MONA OFFSHORE WIND PROJECT

Response to NRW Deadline 3 Submission

Application Reference: EN010137

Document Reference: S_D4_16

Figure 6.1: Seascape character areas and marine character areas of relevance to the Mona Array Area.

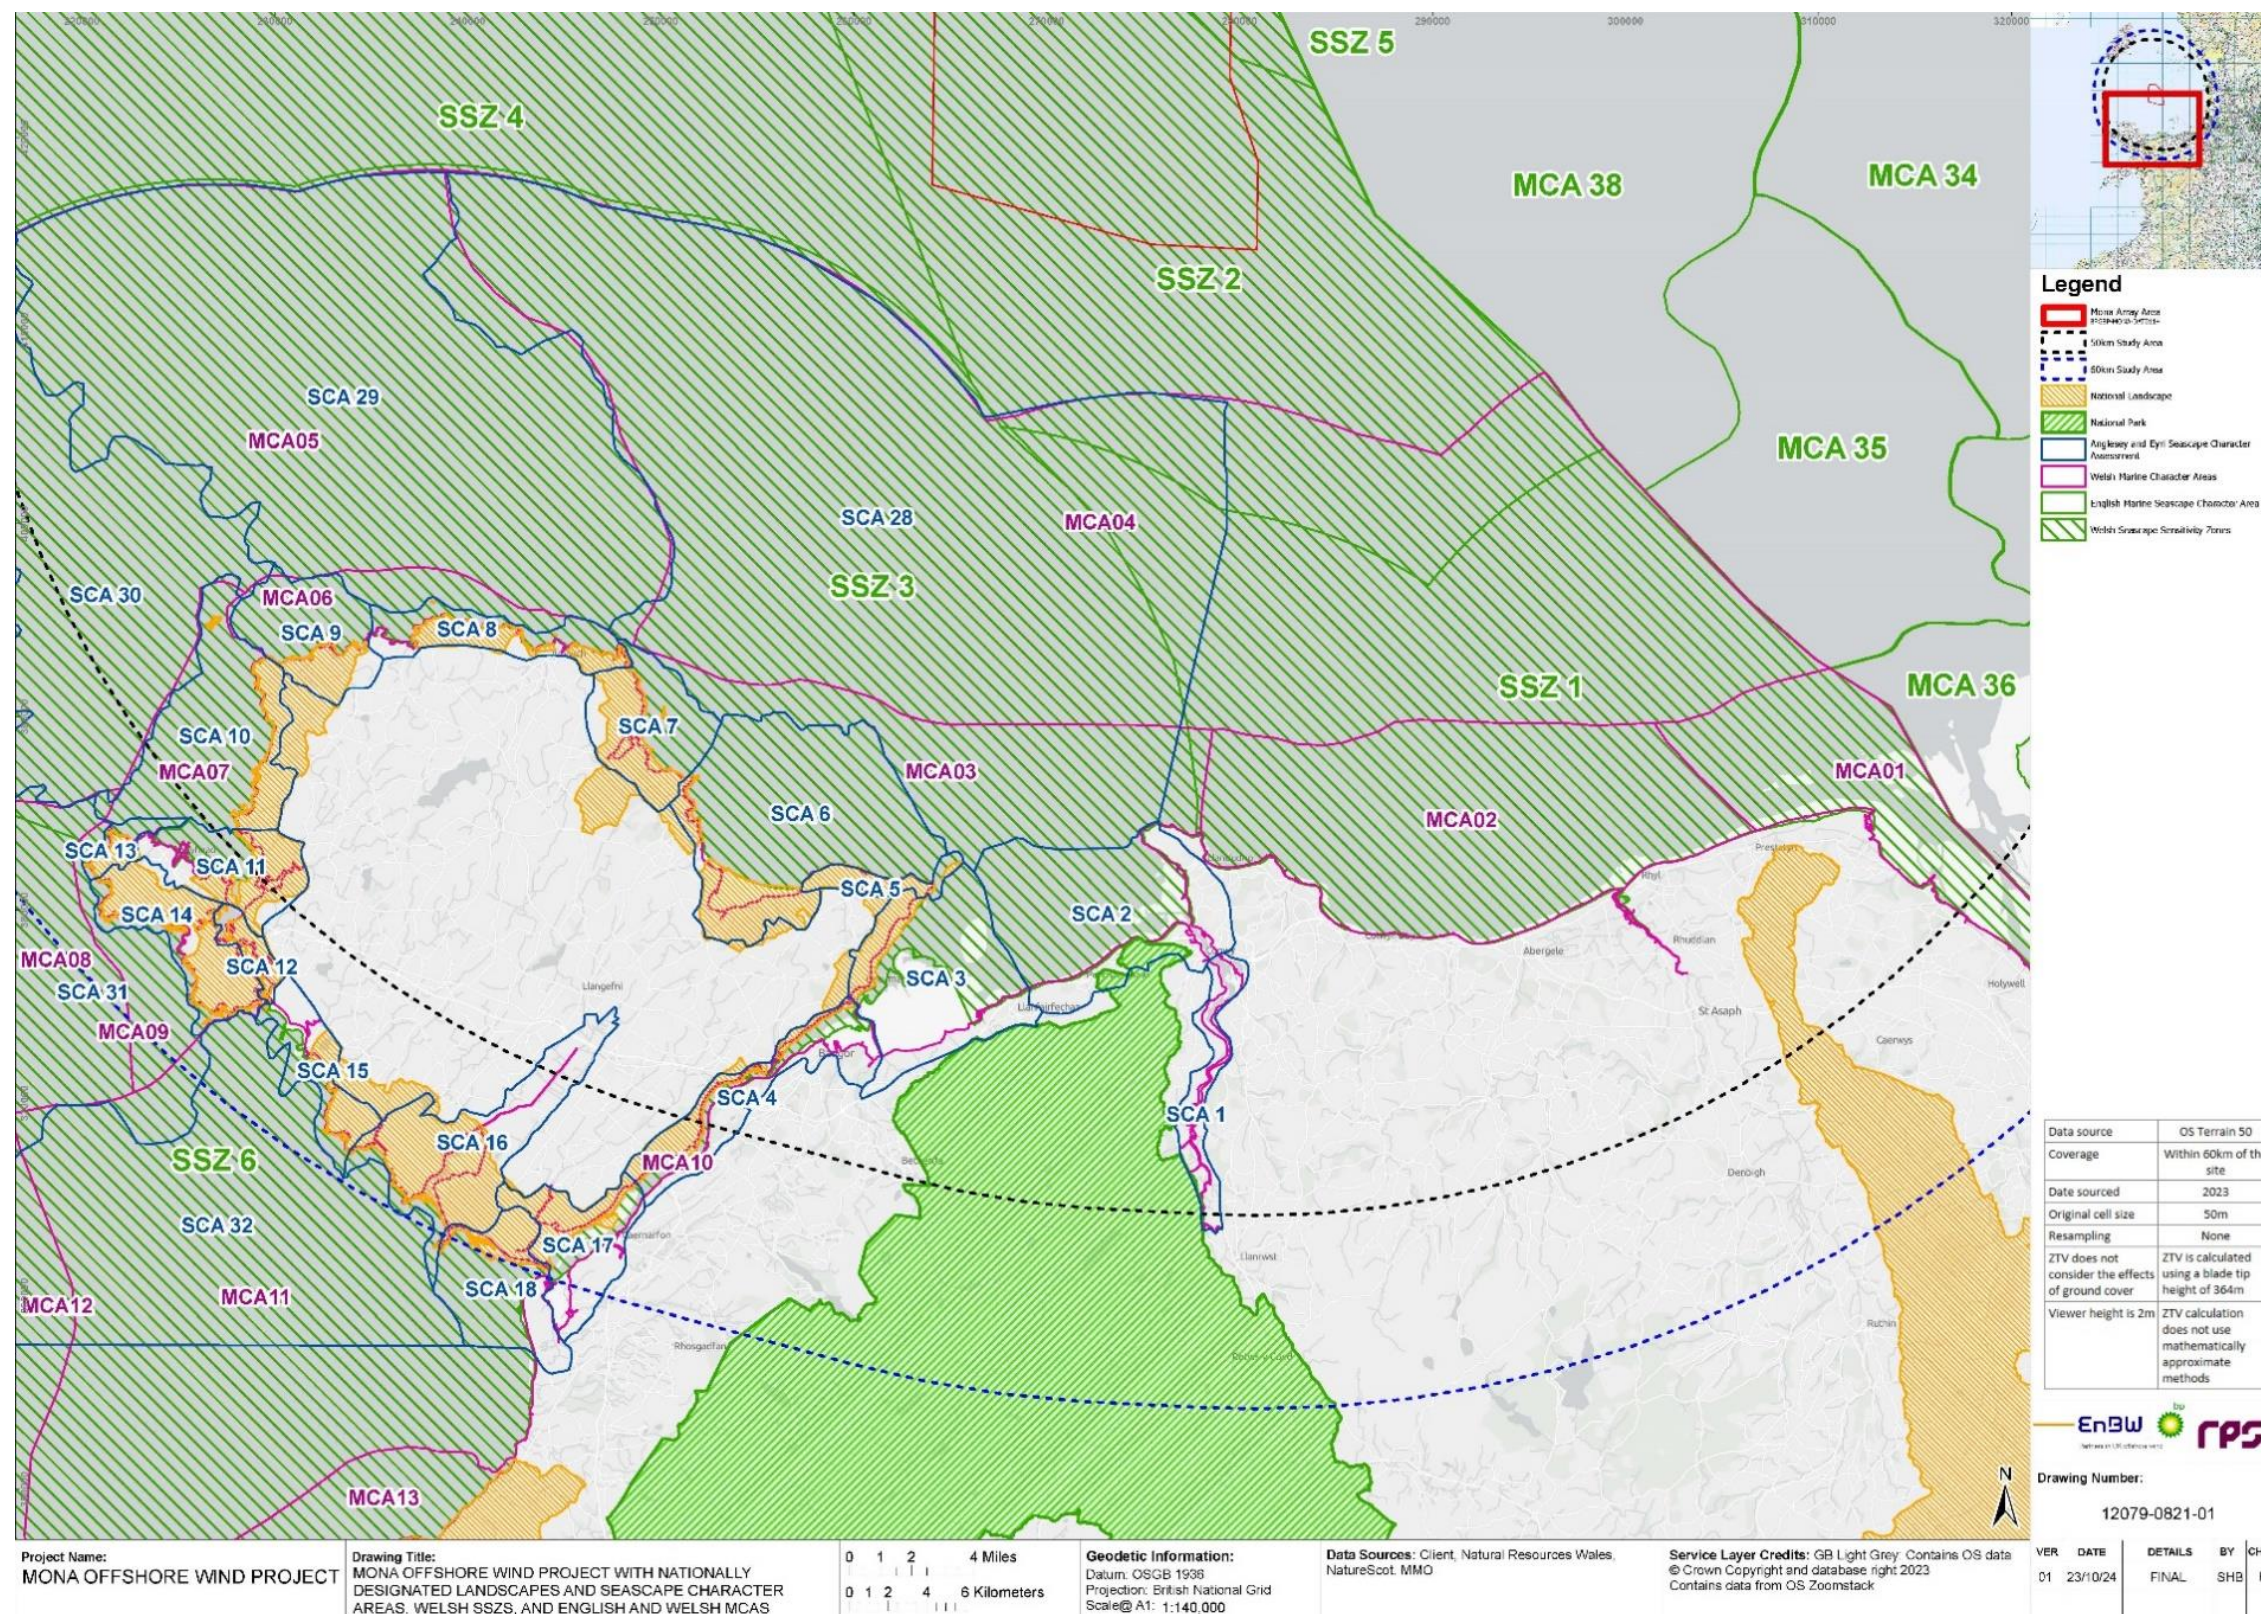
In relation to NRW's comment "*Further, the Mona Array would result in adverse impacts of its own, introducing large scale wind turbine development into an area of sea unaffected by development, at locations where views out to sea contribute to qualities sought to be protected by e.g. the Isle of Anglesey (IoA) National Landscape (NL) designation*", it is the Applicant's position that the character of the seascapes in which the Mona Array Area is located/viewed through are not areas of the sea unaffected by development.

The following sections provides an overview of the seascape character areas of relevance to the Mona Array Area, see Figure 6.1 in Annex C to this response.
